**Meeting Agenda
Plat Committee**

Monday, February 14, 2022

1. [KPB-3742](#) Lost Lake Subdivision 2022 Addition; KPB File 2022-003

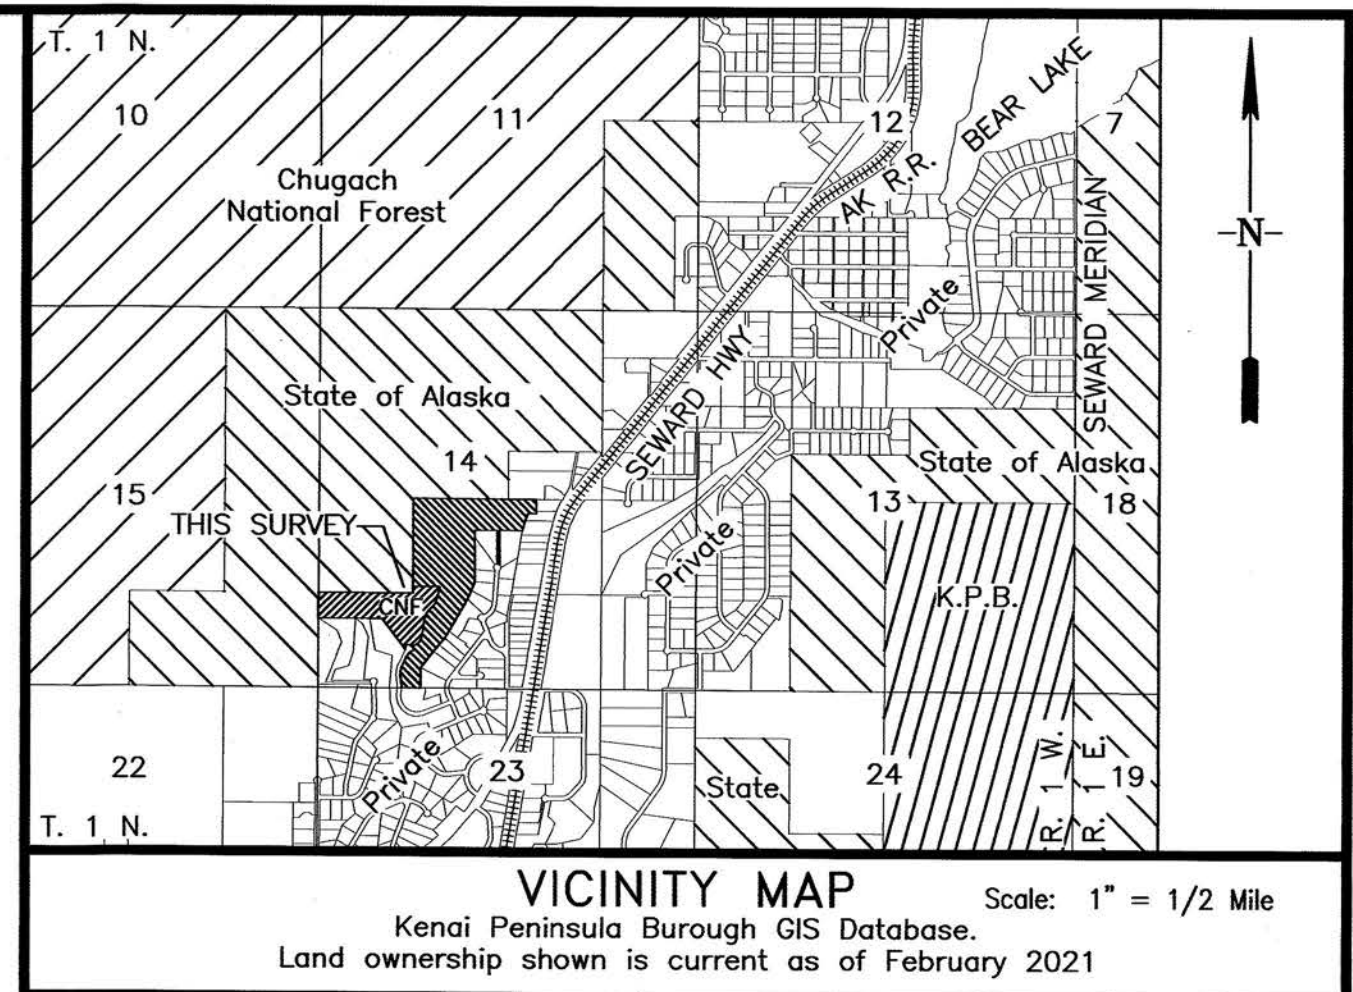
A 33 foot wide section line easement affects the west boundary and the south boundary. **Staff recommends the section line easement be depicted and labeled on the drawing.**

Both tracts will be losing and gaining equal property so the overall size of the parcel will not change. Both parcels are larger than 200,000 sq. ft. so a soils report is not required. **Staff recommends** the appropriate wastewater disposal note per KPB 20.40.030.

- Staff recommendation:** *Revise the name of the plat to Lost Lake Subdivision 2022 Addition. Provide the names and address for all land owners within the title block. Provide the KPB file no. within or near the title block.*

- Staff recommendation:** *Provide the width of the dedication right of ways for Hayden Berlin Road and Judan Road.*
- D. A vicinity map, drawn to scale showing location of proposed subdivision, north arrow if different from plat orientation, township and range, section lines, roads, political boundaries, and prominent natural and manmade features, such as shorelines or streams;

- Staff recommendation:** *Within the new parcels, remove the reference to the parent plat subdivision name. The owner's name is not required within the parcel boundary.*

Staff recommendation: *Concur that labeling former Tract C1 to C7 is advisable as there has already been another Tract labeled C2 within the Lost Lake Subdivision area. Remove the former subdivision name within Tract B2 and Tract C7.*

Staff recommendation: *The survey history information block and the information within plat note 2 is not required by KPB code and can be removed at the discretion of the surveyor. Add notes for any exceptions that are granted by the Planning Commission.*

Staff recommendation: *Provide a Certificate of Ownership for the National Forest Service to sign. With the Certificate of Ownership state which parcels belong to which owner by adding the existing Tract designation under the owner's name.*
